MODEL  
XKR

NUMBER  
J003

**TECHNICAL BULLETIN**

**RECALL: Incorrect Brake Servo Vacuum Supply Hose Routing**

Figure 3

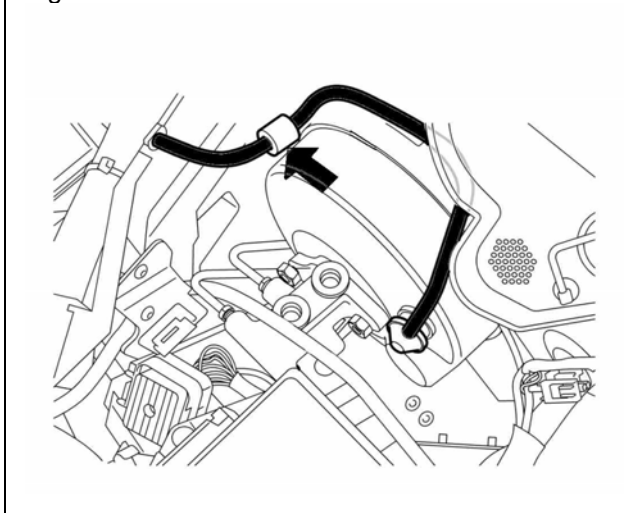
- Remove the four clips, and remove the brake master cylinder cover (Figure 2).
- Disconnect the vacuum line at the quick-connect fitting above the brake servo. (Arrowed in Figure 3)
- Disengage the protective grommet.
- Carefully pull the vacuum line back toward the passenger side of the vehicle to free it from under the hose and AC tubing.

**NOTE: The brake master cylinder reservoir must not be removed from the vehicle. It is shown removed in Figure 3 for illustration clarity only.**

6. If the vacuum hose is determined to be undamaged, perform the following:
- Position the vacuum hose above the rubber coolant hose and steel AC tubing. (Figure 1)
  - Position the protective grommet.
  - Reconnect the quick connect fitting.
7. If **any damage** to the vacuum hose is determined, perform the following:
- Disconnect the installed vacuum hose at the throttle body. (Figure 4)
  - Remove the damaged vacuum hose from the vehicle.
  - Position the replacement vacuum hose above the rubber coolant hose and steel AC tubing.
  - Install the replacement vacuum hose to the throttle body.
  - Position the protective grommet.
  - Reconnect the replacement hose quick connect fitting above the brake servo.
8. Install air intake and engine compartment shielding components removed for access.
